**City of Oakley**  
**ADDENDUM NO. 1 to contract documents for**  
**LAUREL ROAD AND ROSE AVENUE INTERSECTION IMPROVEMENT**  
**AND SIGNALIZATION PROJECT, CIP # 191**

**BID OPENING DATE: January 17, 2019 2:00 PM**

Notice is hereby given that the following clarifications and revisions are made to the above referenced contract documents:

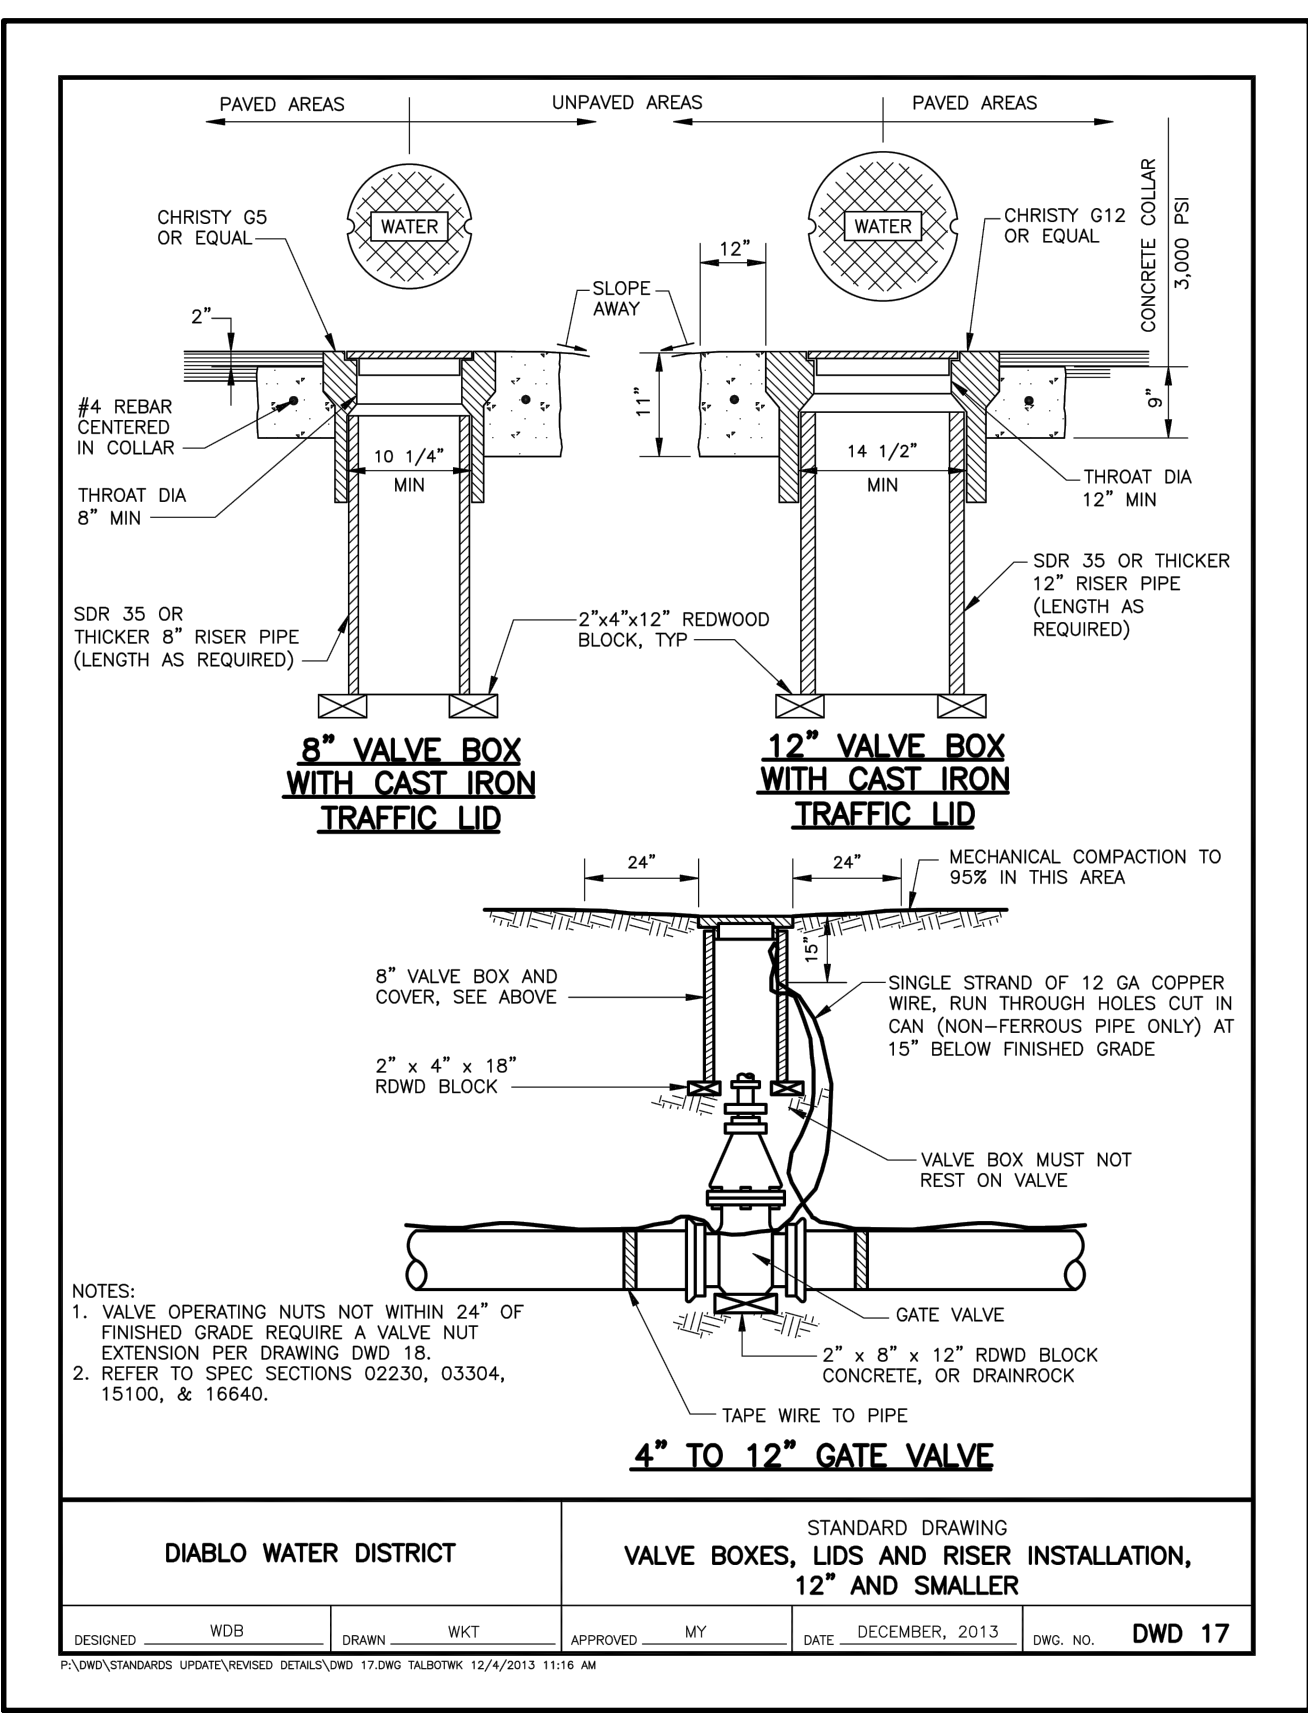
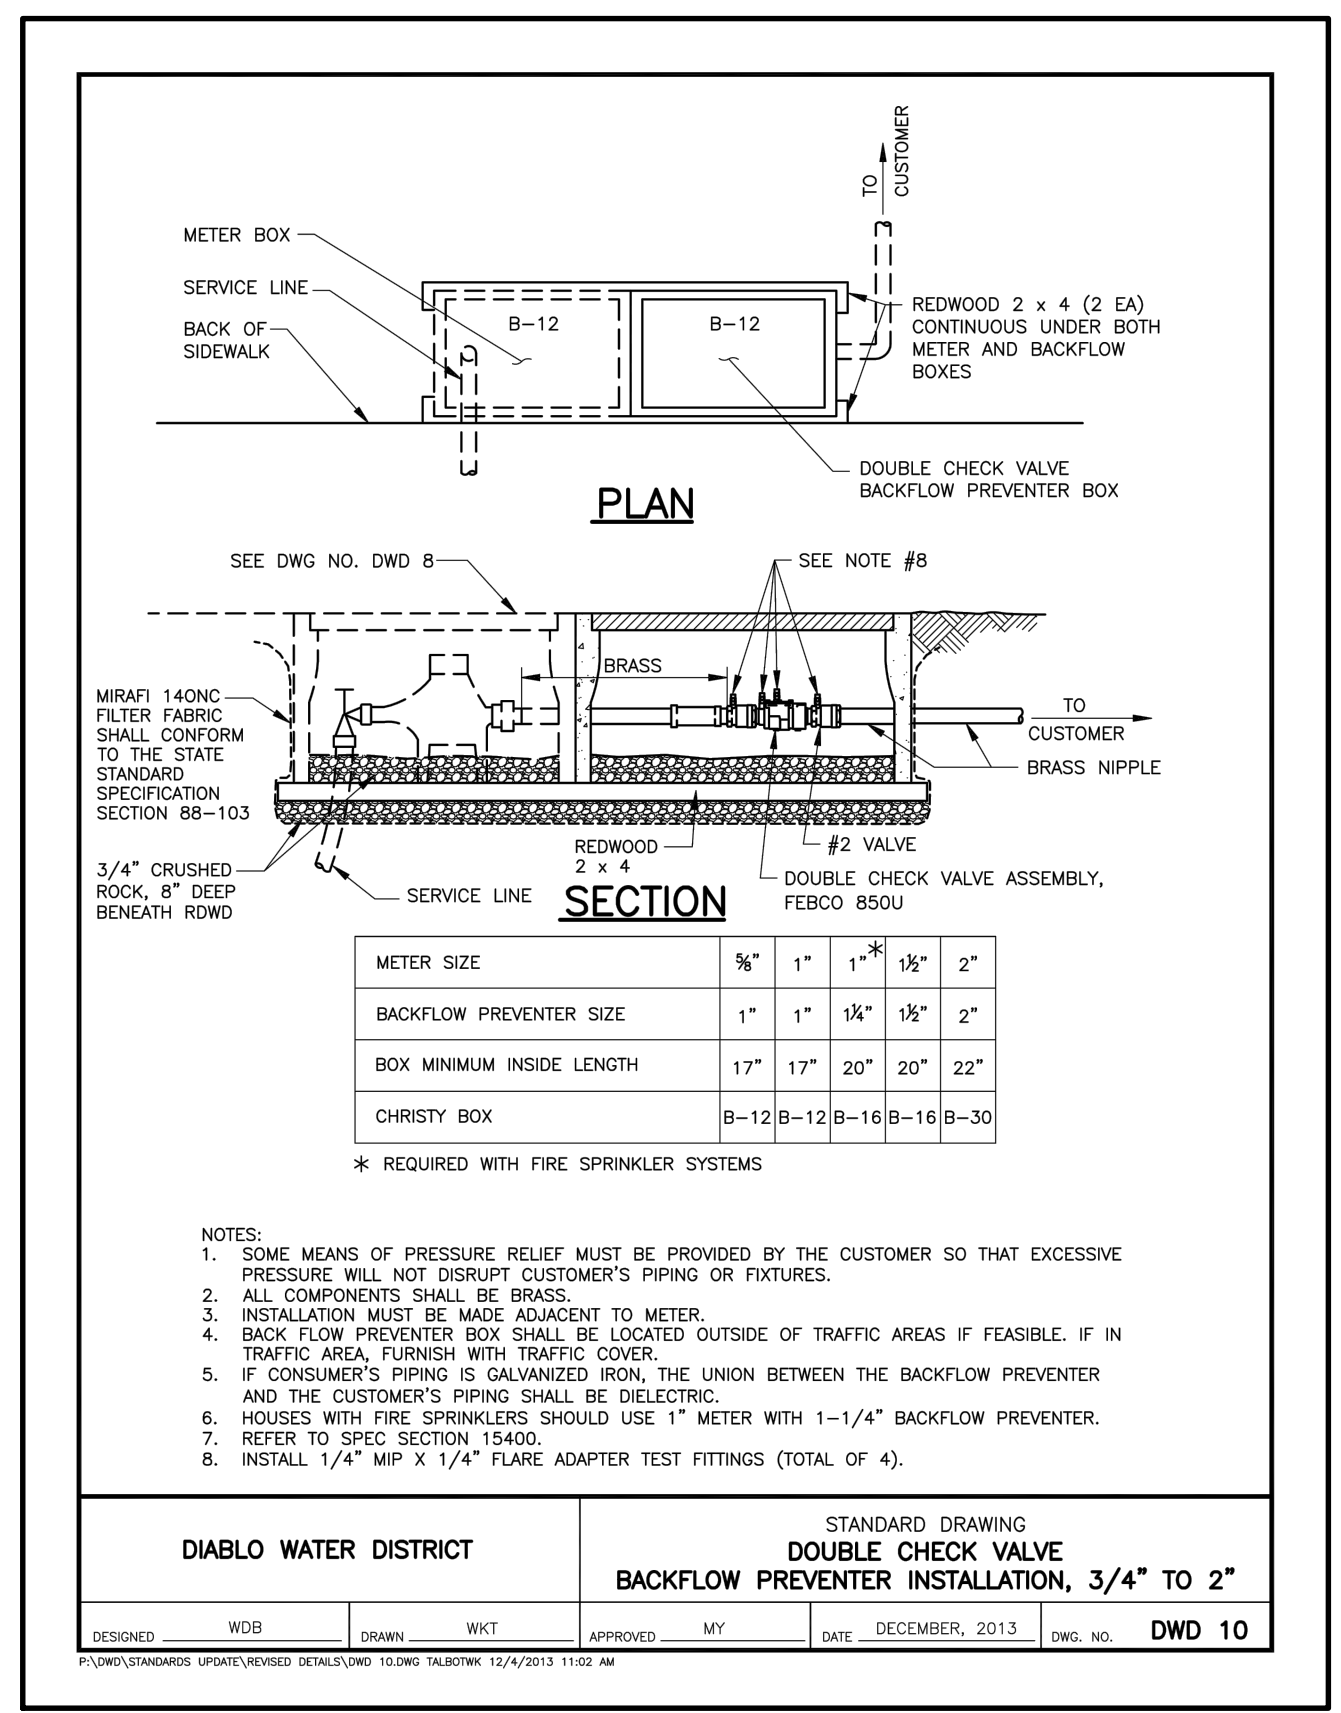
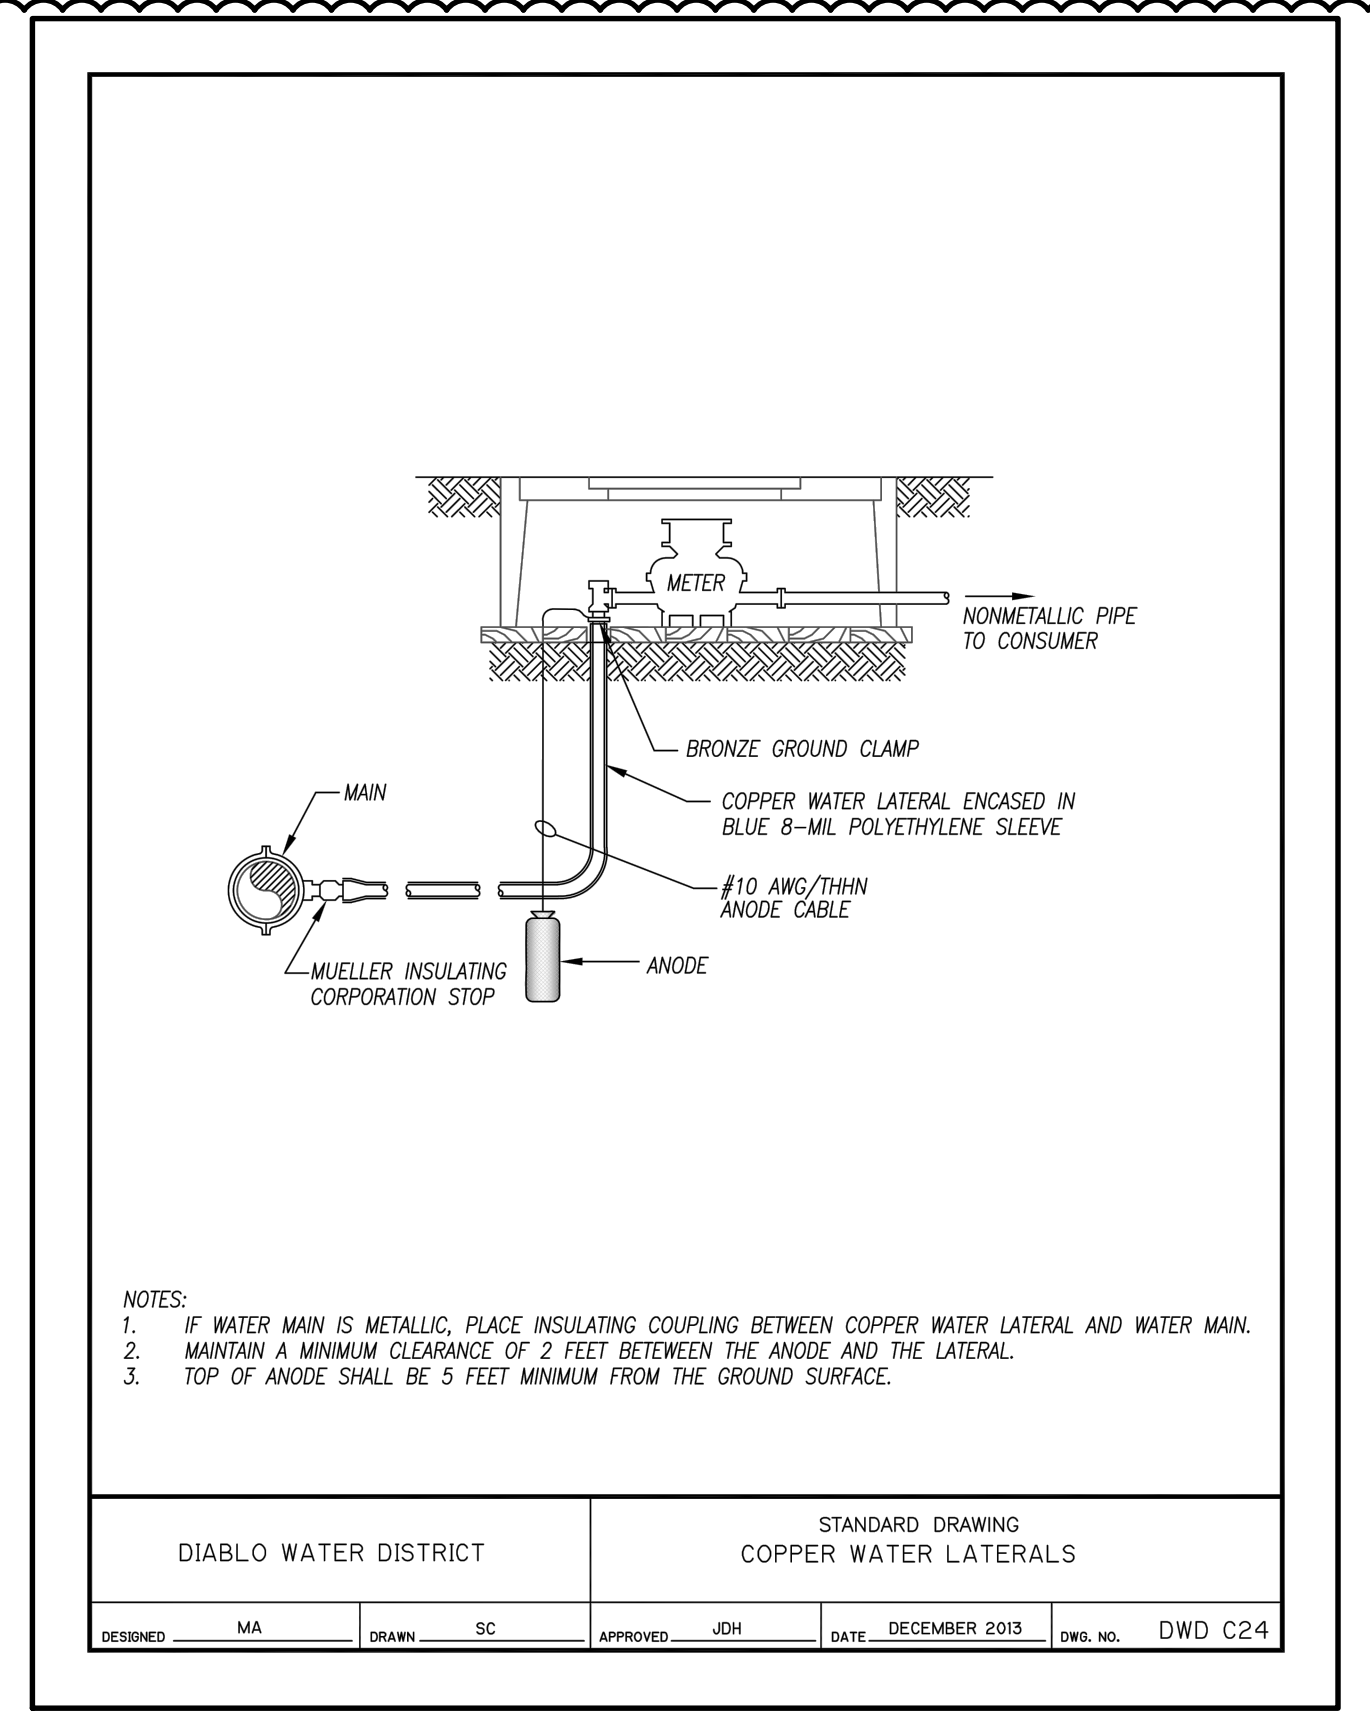
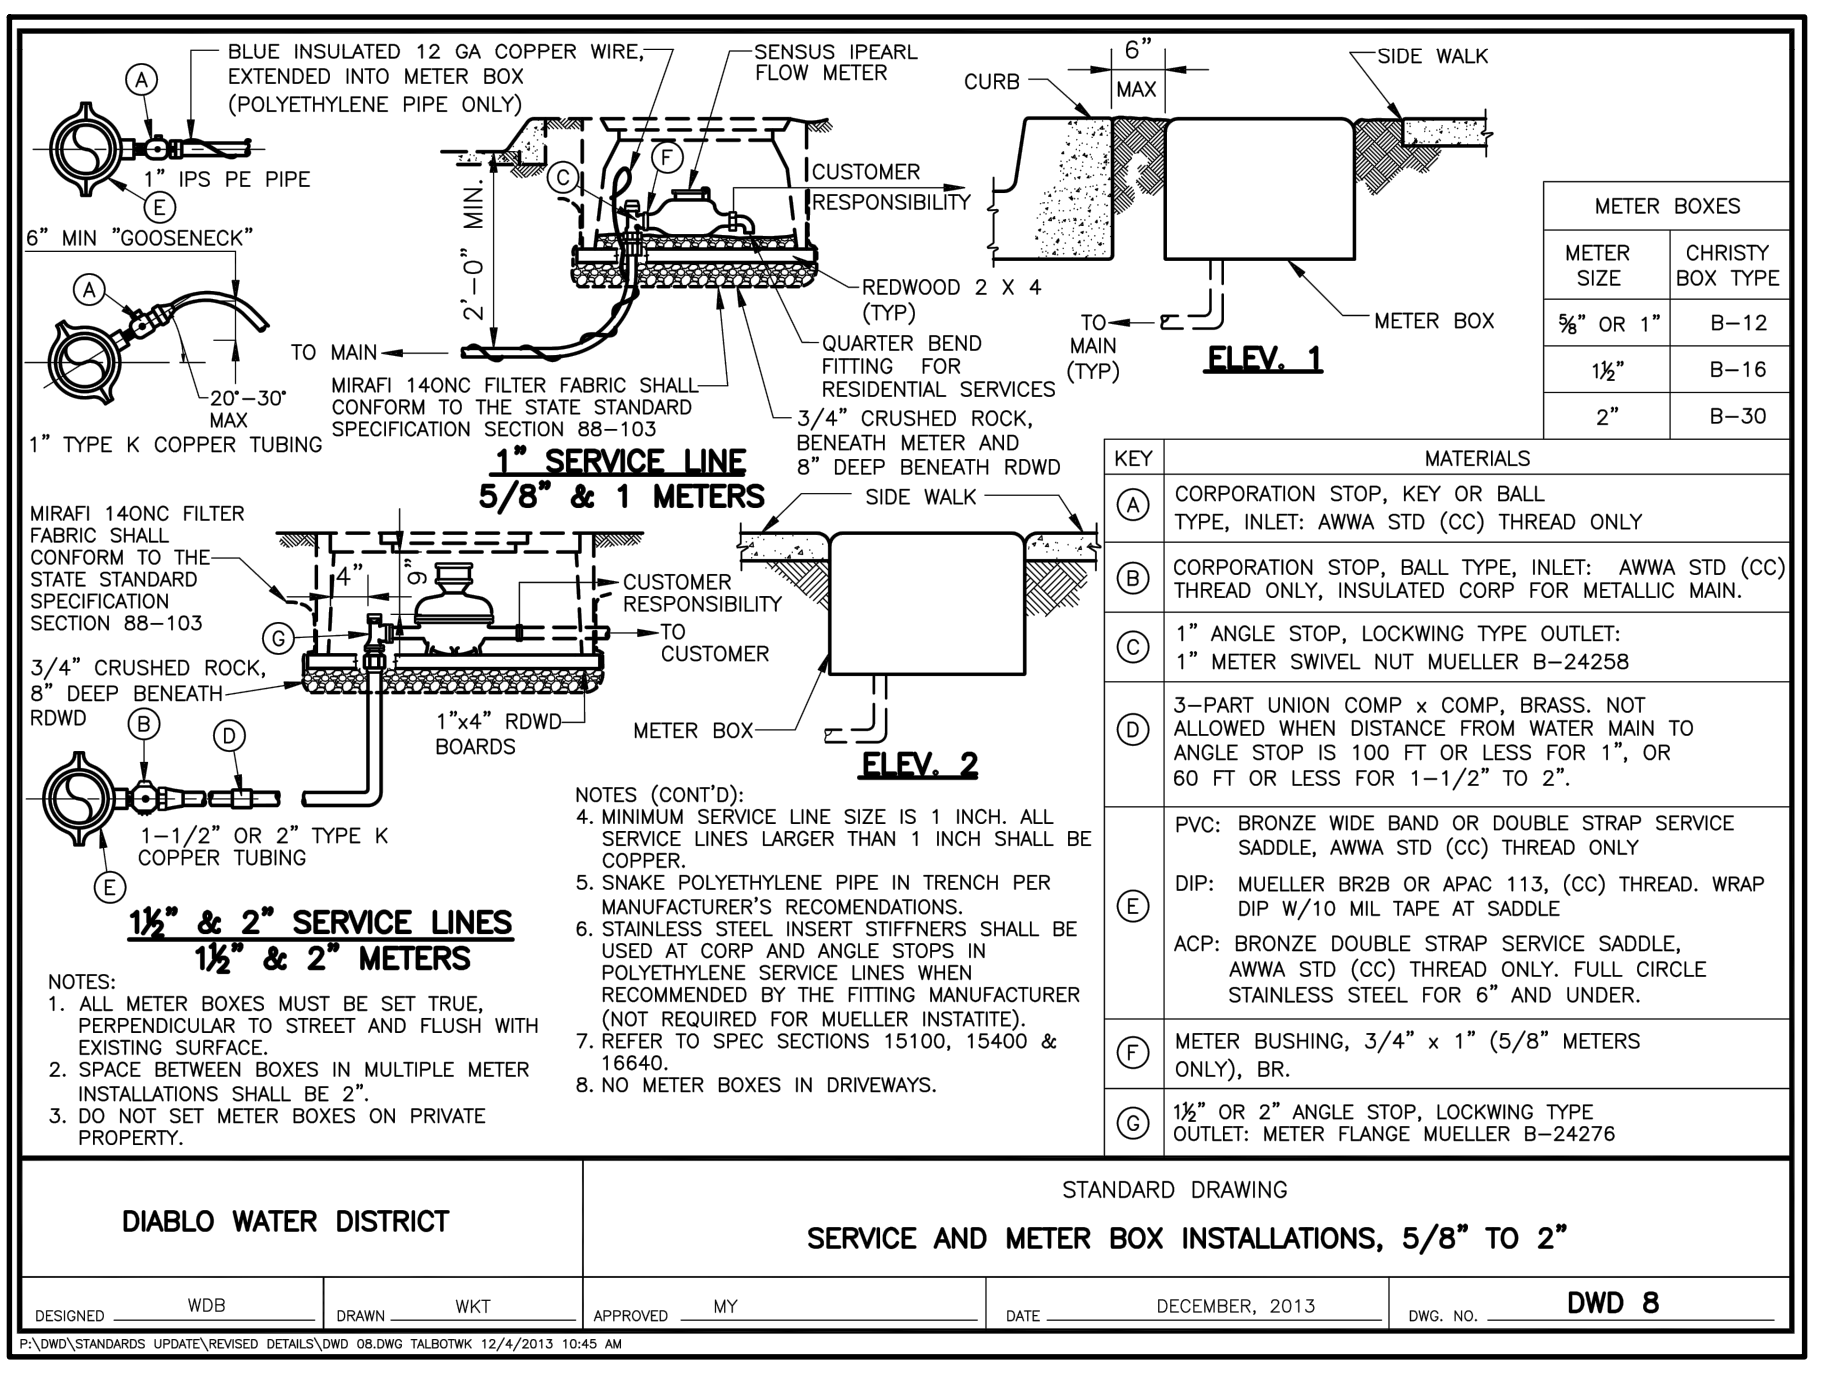
Updated Sheets CD-3, Q-1, U-1 thru U-6, E-1 and E-2
